**CITY PLAN COMMISSION**

**FILE NUMBER:** PLAT-26-000141

**REQUEST:** An application to replat a 1.614-acre tract of land containing all of Lots 1 through 7 in City Block 4/1327, Lots 4 through 7, and part of Lots 3 in City Block 2/1336 to create one lot on property located on Shelby Avenue, southwest of Dickason Avenue.

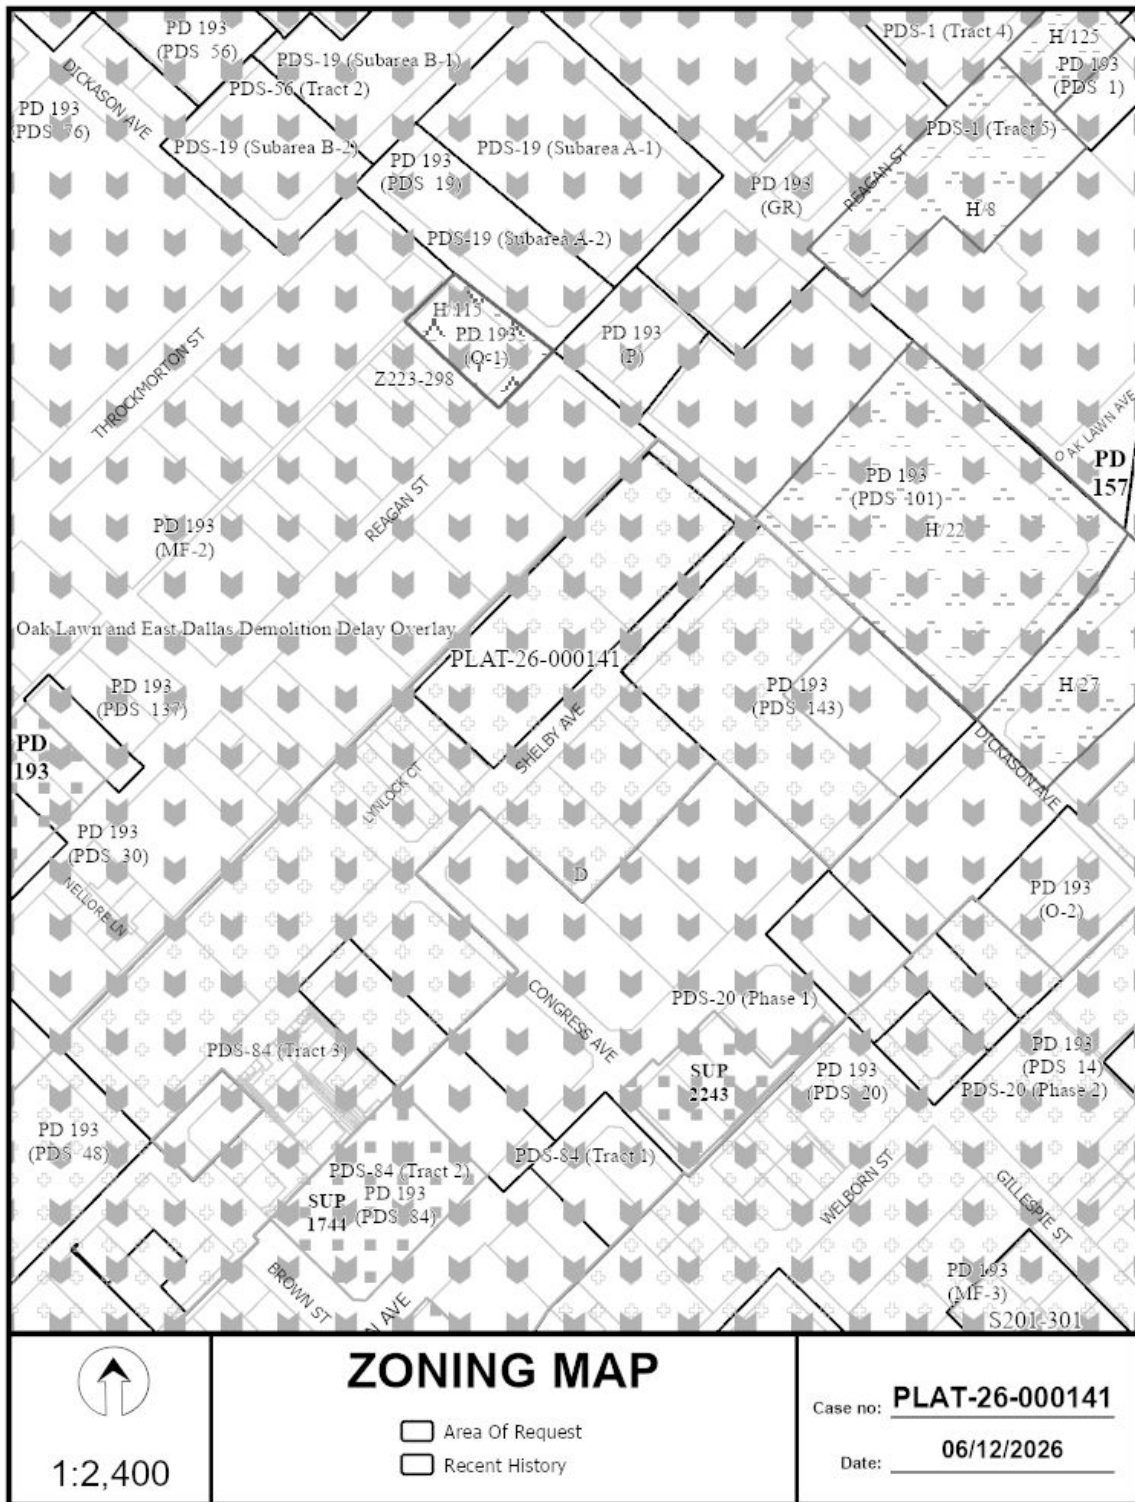
15. Dedicate 7.5 feet of right-of-way (via fee simple) from the established center line of Alley. Section 51A 8.507(b)(1). 51A 8.602(c)
16. Dedicate 28 feet of right-of-way (via fee simple or street easement) from the established center line of Dickason Avenue & Shelby Street. Section 51A 8.602(c); 51A 8.604(c).

17. Dedicate a minimum 5-foot by 5-foot corner clip (via fee simple or street easement) at Dickason Avenue and Shelby Street. Section 51A 8.602(d)(1).
18. A larger corner clip may be requested during engineering plan and traffic review to accommodate an adequate turning radius, or to maintain public/traffic appurtenances, within the area of the corner clip. 51A 8.602(d)(1), 51A 8.608(a).

19. Dedicate 15-foot by 15-foot alley sight easement at Dickason Avenue Section 51A 8.602(e).
20. On the final plat, include a note that the site is within the \_ 60\_DNL contour of \_ Love Field\_ airport and this noise level may require special construction standards for certain uses per the building code. Dallas Building Code, Section 425.

27. On the final plat, add "Lynlock Court".
28. On the final plat, identify the property as Lot 4A in City Block 2/1336.
